2013 Leon Creek Water Recycling Center (WRC) Rehabilitation and Process Improvements

SAWS Job No.: 13-6505

Addendum No. 4

August 18, 2015

1 OVERALL SITE PLAN
1" = 100'

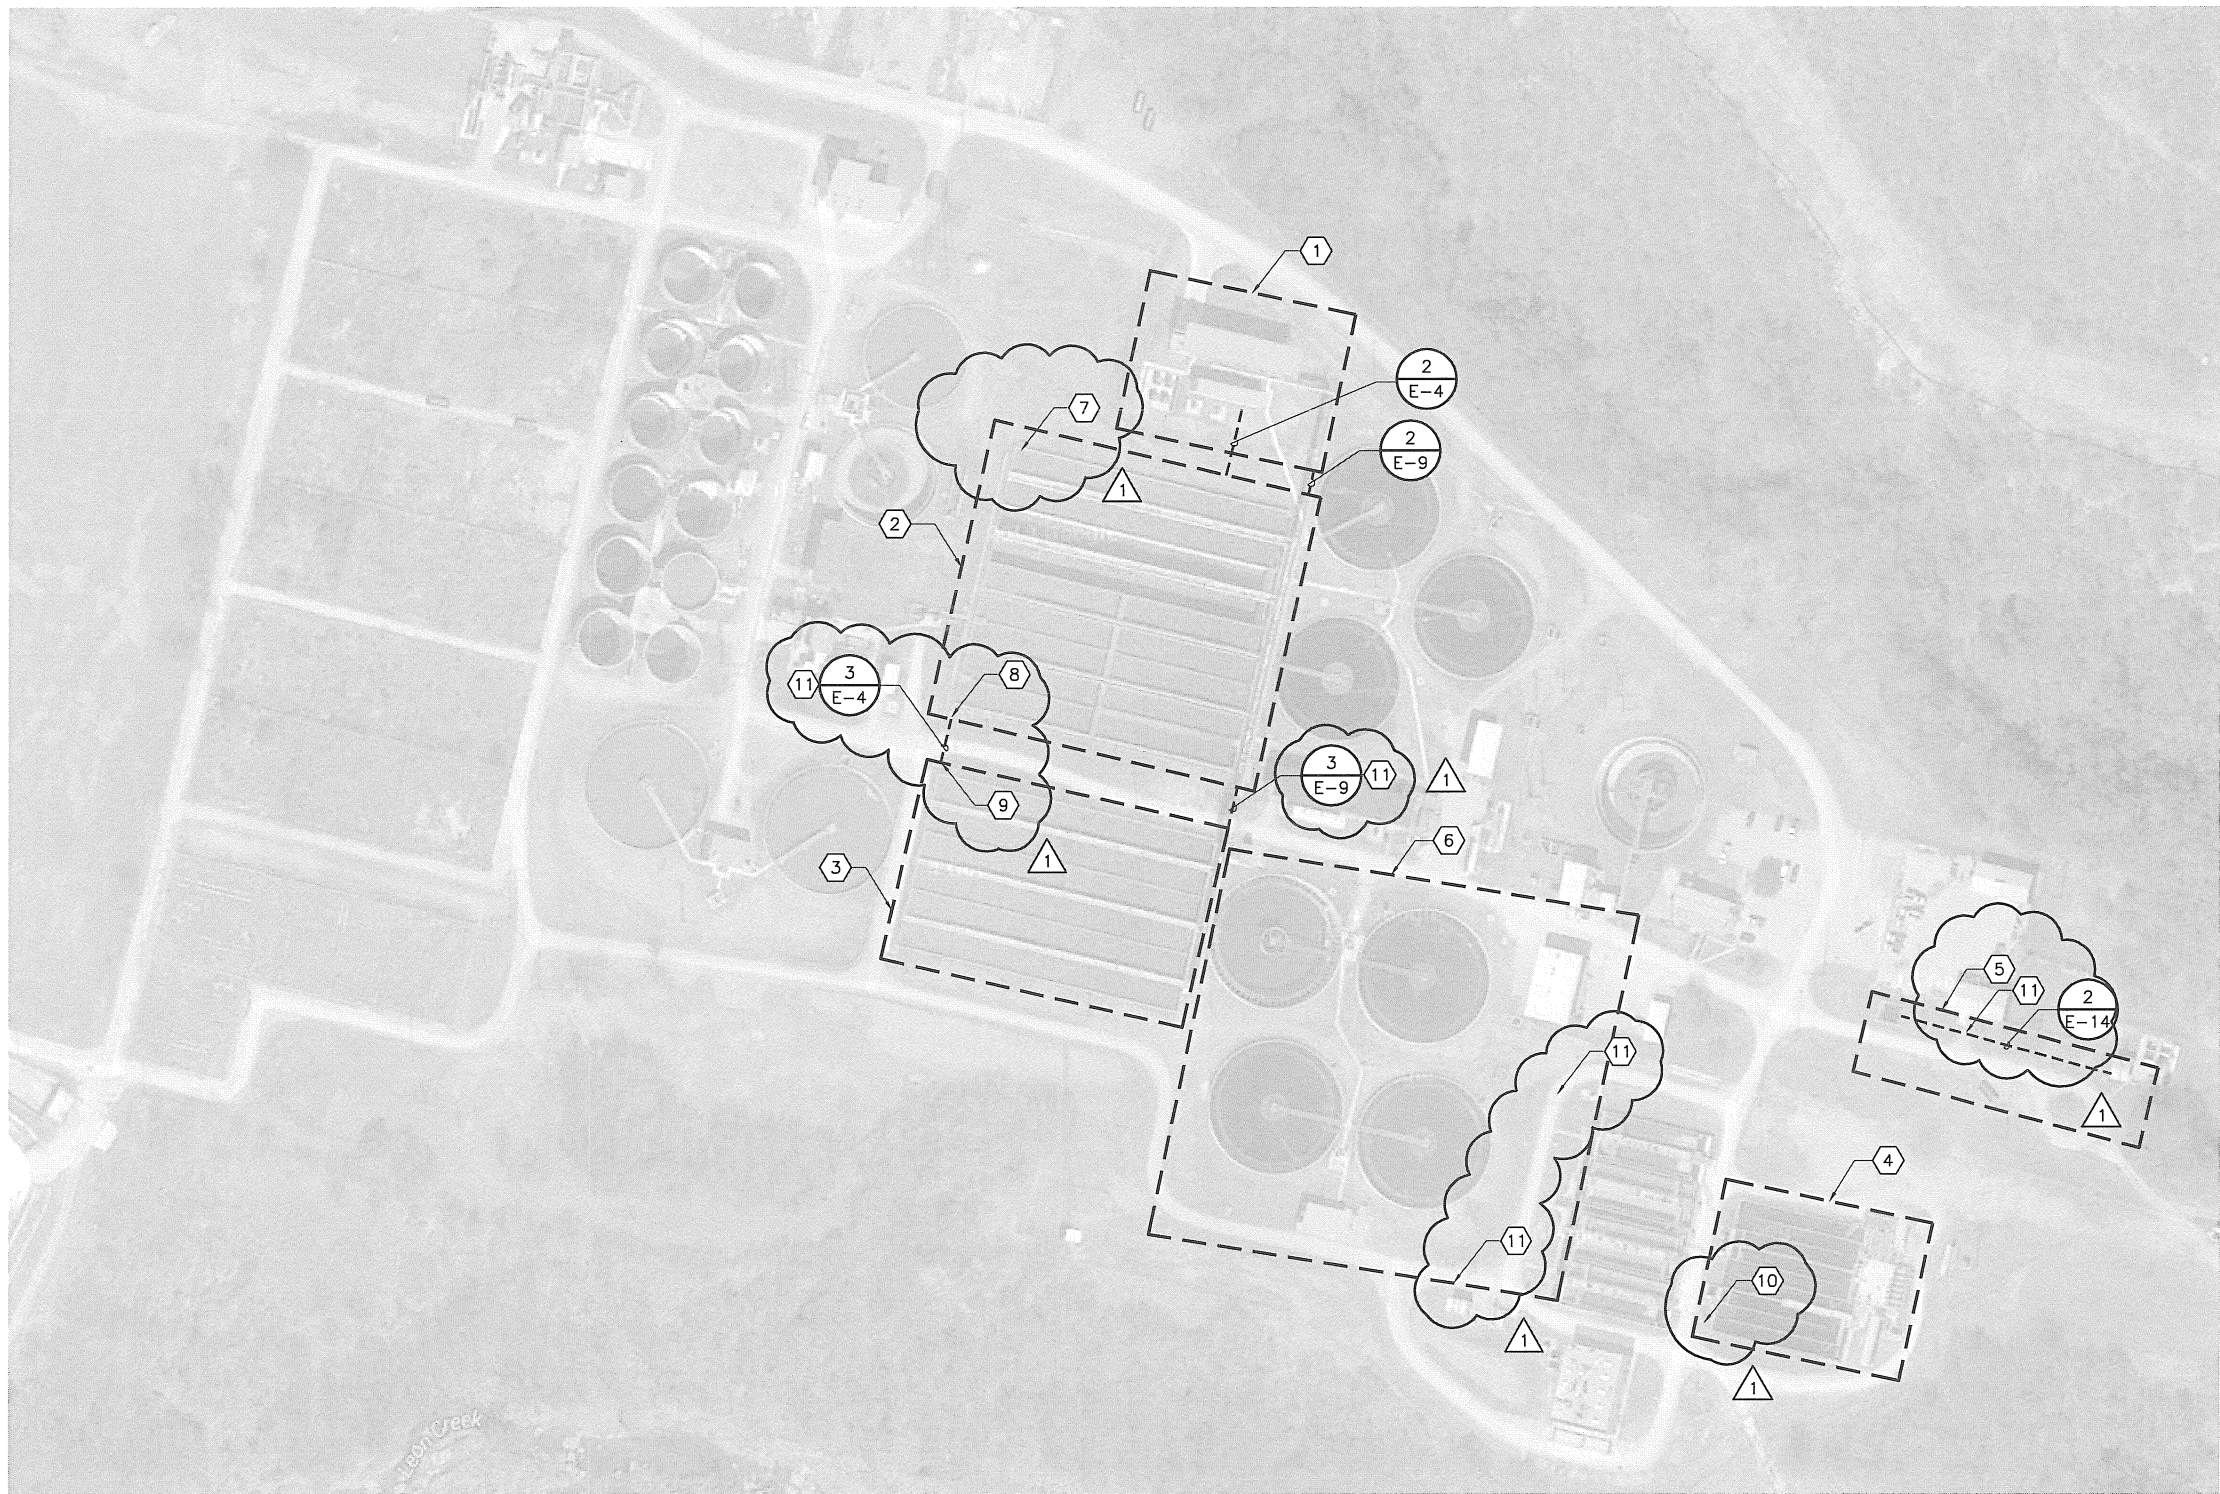
4. **Question:** Please reference Sheet M-17 in the project plans. Detail 1 for the pavement repair detail and detail 2 for the embedded bollard detail are not shown anywhere on the plans to be installed or placed. Where do these items pertain to?
 - **Answer:** The bollard detail (M-17/2) pertains to bollards referenced on the electrical sheets for protection of control panels and additional electrical equipment. The pavement repair detail (M-17/1) pertains to the repair of plant roadway related to the installation of duct banks shown on the electrical sheets. Please see revised Sheet E-3 in Addendum No. 4 for further clarification on the locations of the bollards and pavement repairs.

1. BLOWER AND ELECTRICAL BUILDING AREA, RE: 1/E-11 FOR ADDITIONAL WORK IN THIS AREA.
2. AERATION BASINS 7-15 AREA, RE: 1/E-8 FOR ADDITIONAL WORK IN THIS AREA.
3. AERATION BASINS 1-6 AREA, RE: 1/E-7 FOR ADDITIONAL WORK IN THIS AREA.
4. CHLORINE CONTACT BASIN AREA, RE: 1/E-13 FOR ADDITIONAL WORK IN THIS AREA.
5. DIVERSION BOX "D" AREA, RE: 1/E-14 FOR ADDITIONAL WORK IN THIS AREA.
6. CLARIFIERS AREA, RE: 1/E-15 FOR ADDITIONAL WORK IN THIS AREA.
7. CONTRACTOR SHALL INSTALL TWO BOLLARDS IN FRONT OF PANELS 13 AND 13A. RE: 2/M-17 FOR DETAILS.
8. CONTRACTOR SHALL INSTALL TWO BOLLARDS IN FRONT OF PANEL 13B. RE: 2/M-17 FOR DETAILS.
9. CONTRACTOR SHALL INSTALL TWO BOLLARDS IN FRONT OF PANEL 13C. RE: 2/M-17 FOR DETAILS.
10. CONTRACTOR SHALL INSTALL TWO BOLLARDS IN FRONT OF MEDIA CONVERTER PANEL. RE: 2/M-17.
11. CONTRACTOR SHALL PATCH ASPHALT AFTER INSTALLING DUCT BANK. RE: 1/M-17 FOR DETAILS.
